1875 WESTLAKE DR
NORRIS BOAT DOCK

SP-2020-0223DS

Hydrogeologic Reviewer

REQUEST TO VARY FROM LDC 25-8-
281(C)(2)(B) TO ALLOW CONSTRUCTION
WITHIN A CRITICAL ENVIRONMENTAL
FEATURE (CEF) BUFFER.

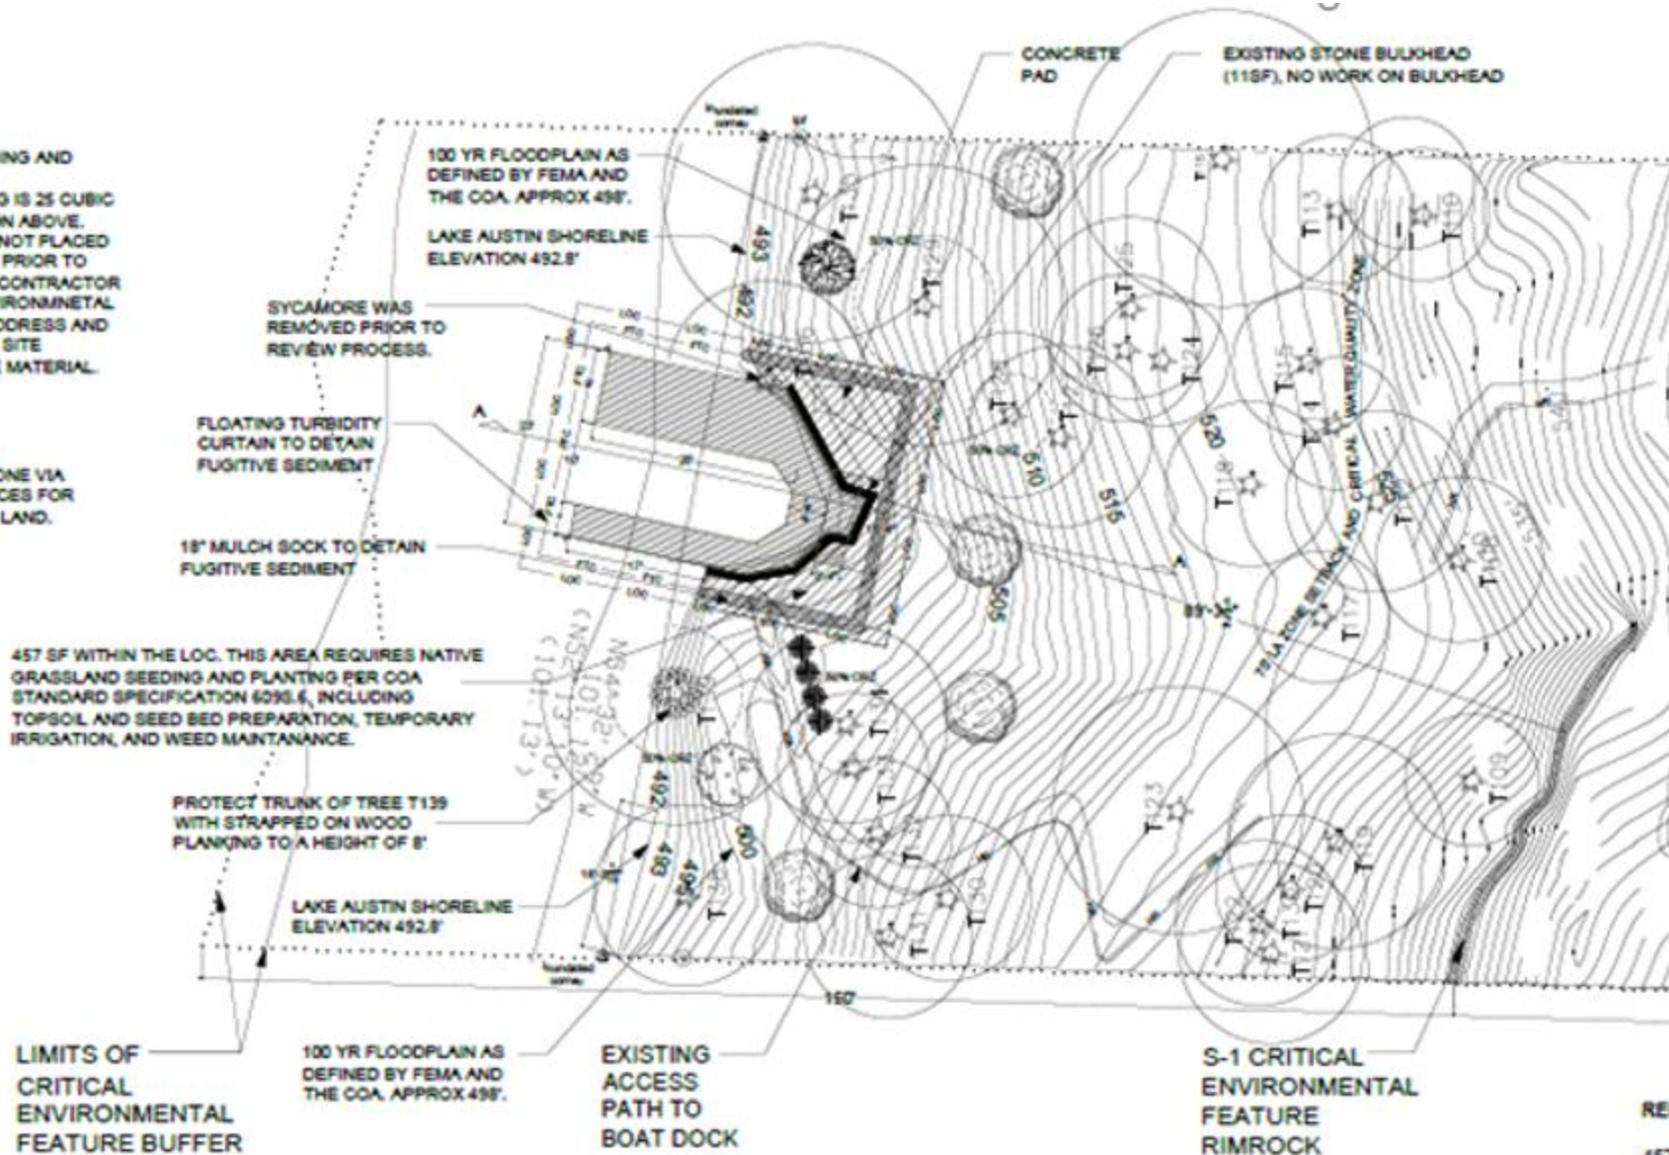
- Dock construction is proposed at bottom of slope, with Limits of Construction (orange) as far from Rimrock CEF (purple) as is feasible.
- No new shoreline access is proposed between house and new dock.

**VARIANCE
RECOMMENDATION**

FINDING OF FACTS HAVE BEEN MET.

STAFF RECOMMENDS THE APPROVAL OF THIS
VARIANCE WITH THE CONDITION THAT ALL
CONSTRUCTION BE COMPLETED BY BARGE.

Drawing Type:	PLANS
Site Plan No.	SP-2020-0223DS
Sheet:	03
Revision:	A
Revision:	Description:
Revision:	Description:
Date:	3/17/2021
Drawn By:	C. MALEK

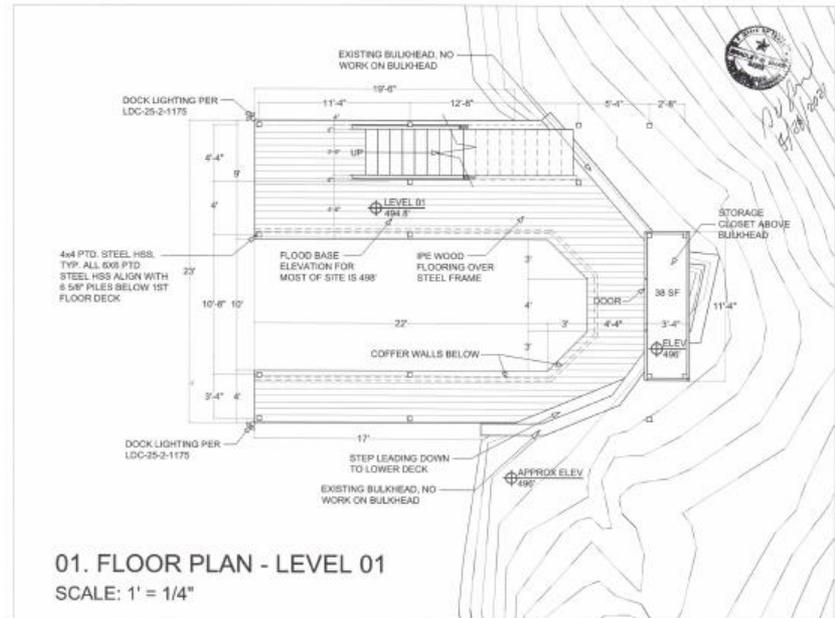
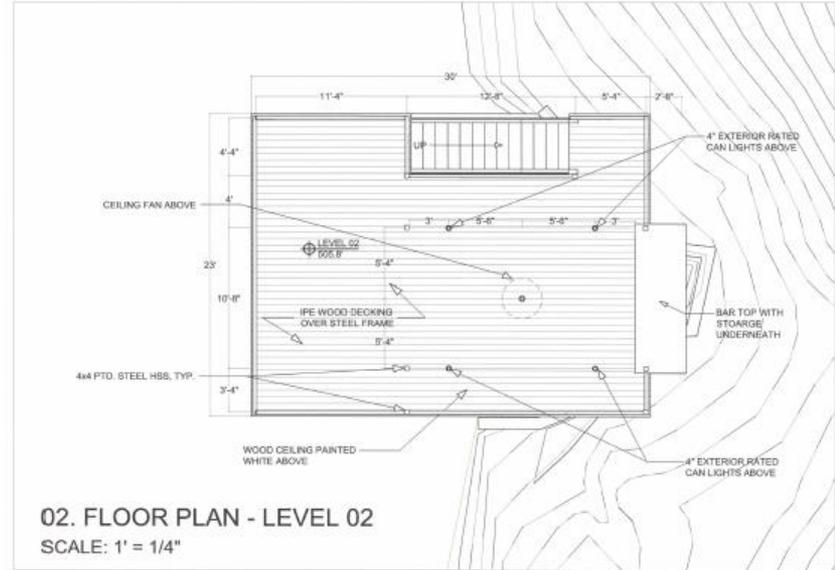
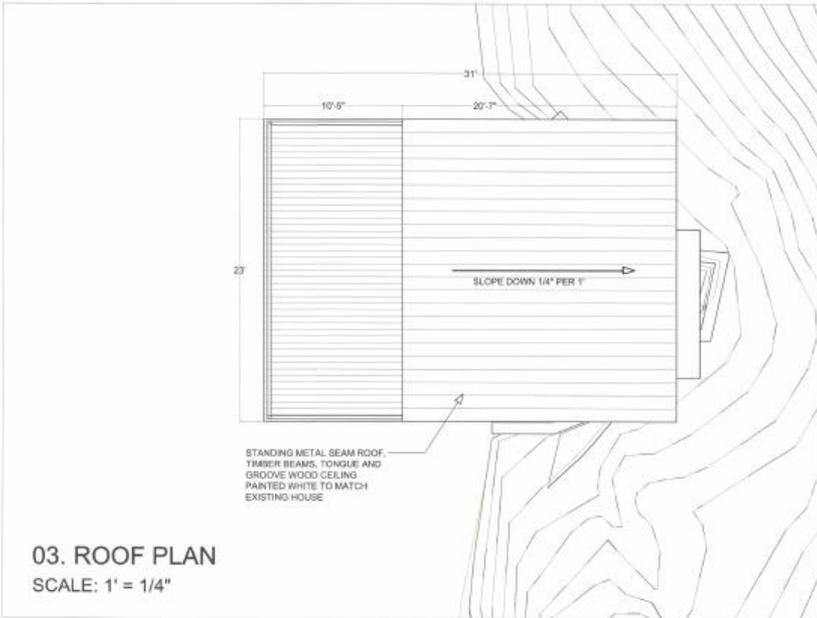
PROPOSING DREDGING AND COFFER WALLS. MAXIMUM DREDGING IS 25 CUBIC YARDS. SEE SECTION ABOVE. DREDGE MATERIAL NOT PLACED BEHIND SHEETPILE. PRIOR TO OFFSITE DISPOSAL CONTRACTOR MUST PROVIDE ENVIRONMENTAL INSPECTOR WITH ADDRESS AND PHONE NUMBER OF SITE RECEIVING DREDGE MATERIAL.

ALL WORK TO BE DONE VIA BARGE. NO SITE ACCESS FOR CONSTRUCTION BY LAND.

457 SF WITHIN THE LOC. THIS AREA REQUIRES NATIVE GRASSLAND SEEDING AND PLANTING PER COA STANDARD SPECIFICATION 6095.6, INCLUDING TOPSOIL AND SEED BED PREPARATION, TEMPORARY IRRIGATION, AND WEED MAINTANANCE.

PROTECT TRUNK OF TREE T139 WITH STRAPPED ON WOOD PLANKING TO A HEIGHT OF 8'
